ENGINE - ENGINE HP COMPRESSOR DISCS (STAGES 3 TO 8) - INTRODUCTION OF REVISED STAGE 7
AND 8 SEAL WIRES - CATEGORY CODE 6 - MOD.ENG-72-0289

V2500-ENG-72-0289

General section through the HP compressor - Before and after alteration
Fig.1

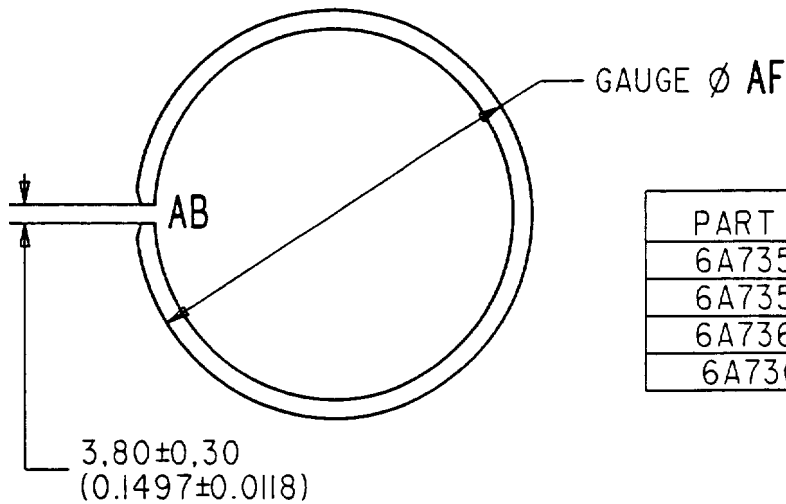
(1) The stage 7 and 8 front and rear seal wires of the HP compressor have changed as follows:

(a) A fillet has been added that rounds off the ends of the wire at the split line.

(b) The chamfer has decreased from 30 to 15 degrees.

(2) The front and rear seal wires that exist can be reworked. (Refer to Fig.1 and Fig.2)

| (c) Grind back the chamfer and make the radius 'AD' on the ends of the Stage 7 and 8 front and rear wire seals | Use a grinding machine and/or standard workshop equipment. (Refer to Figure 1 and Figure 2). |
| (d) Remove sharp edges | Use CoMat 05-106 abrasive stone and/or CoMat 05-111 emery polishing paper, with standard workshop equipment. (Refer to Figure 1 and Figure 2). |

- Make sure all marks are completely removed and the repaired area is made smooth into the adjacent material.
(Refer to Figure 1 and Figure 2).
- (f) Etch the repaired area with the cold ferric chloride procedure

- Make sure the end 'AD' has a good radius and that there is no sharp edges around the repaired area.
Use workshop inspection equipment.
(Refer to Figure 1 and Figure 2).

View of rework of seal wires
Fig.2

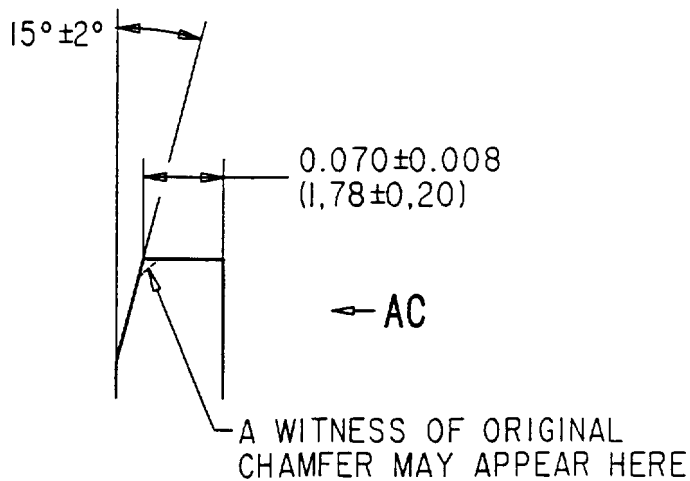
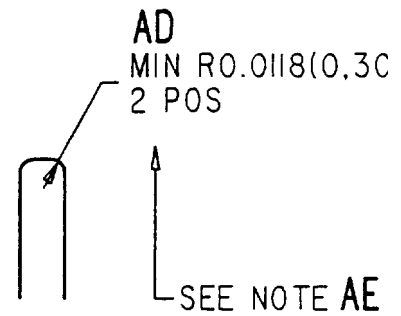
NOTE AE
BOTH ENDS MAY VARY BETWEEN RADUS AD AND FULL RADIUS
